## Architectural Control Committee

### Plan and Specification Review Determination

#### LANDSCAPE APPLICATION (page 1 of 3)

Address 16326 AND 16308 - 7TH AVE. SE

CURRENT LANDSCAPE 6/23

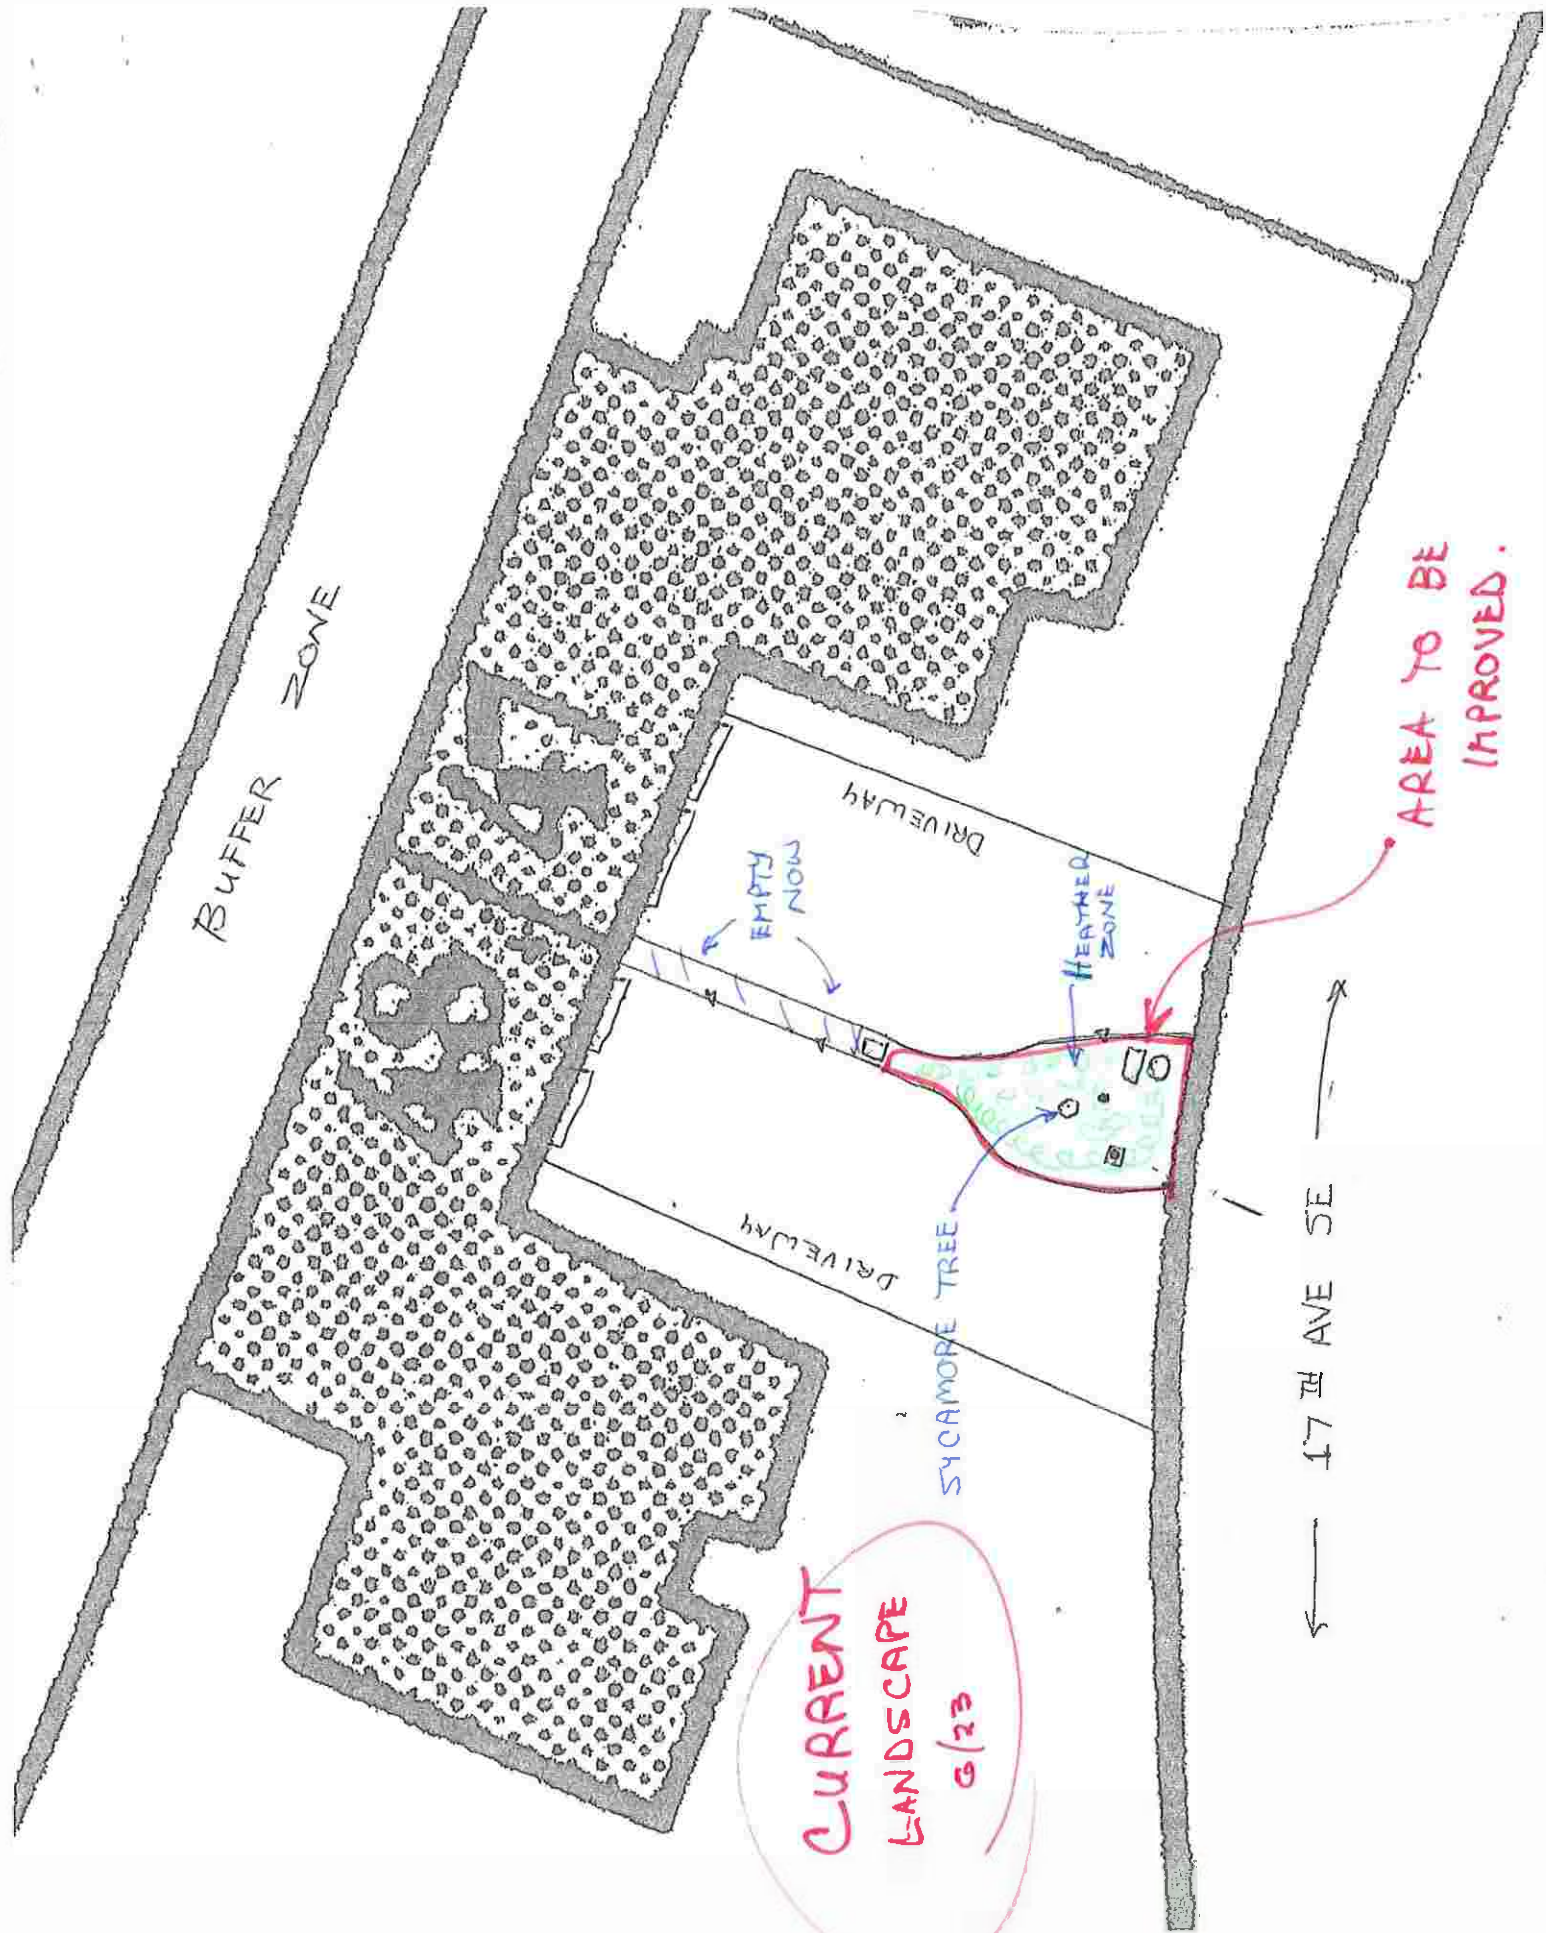
NORTH SIDE, ONLY  
BEARING N. OR  
WESTERN TREES  
AND REMOVED BY  
THE HOA AND A  
NEW TREE PLANTED  
AT EXPENSE OF  
HOA. - SEE OTHER  
PAGE →  
APPROVED

IN THIS CASE /  
HOA WILL PAY  
TO HAVE THE  
TREE REMOVED  
M.S. /

HOA DOES  
NOT REPLACE  
PLANTS IN  
OWNER'S YARDS.  
THE HOA DOES  
REMOVE DEAD,  
Dying OR DISEASED  
TREES AND SHRUBS.

DENIED  
M.S. / M

I have seen the cracking and upheaval of the driveways caused by the existing tree roots. In this instance, we agree the tree should be removed and the stump ground at HOA expense. The HOA will not pay for a replacement street tree (specie to be determined) as that will be your expense as will any approved plantings.
